MASTER REVIEW REPORT

CASE NUMBER: C814-89-0003.02
CASE MANAGER: Kate Clark

REVISION #: 02
PROJECT NAME: 305 S. Congress

LOCATION: 305 South Congress Avenue

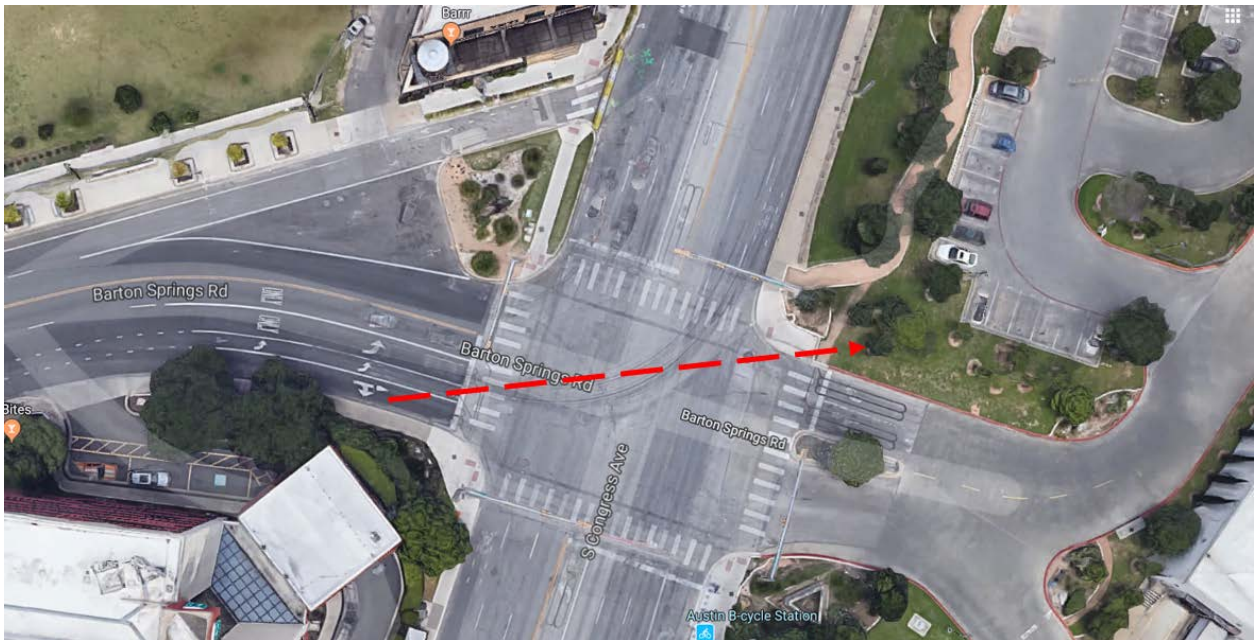
- EO 1. Please provide a redlined copy of the existing PUD ordinance and all plan sheets.
- EO 2. Provide a code comparison table, similar to what is shown below that outlines Current Code, Current PUD entitlements, and Proposed PUD. The applicant can reach out for a copy of the spread sheet since below is only an example and does not include the chart.
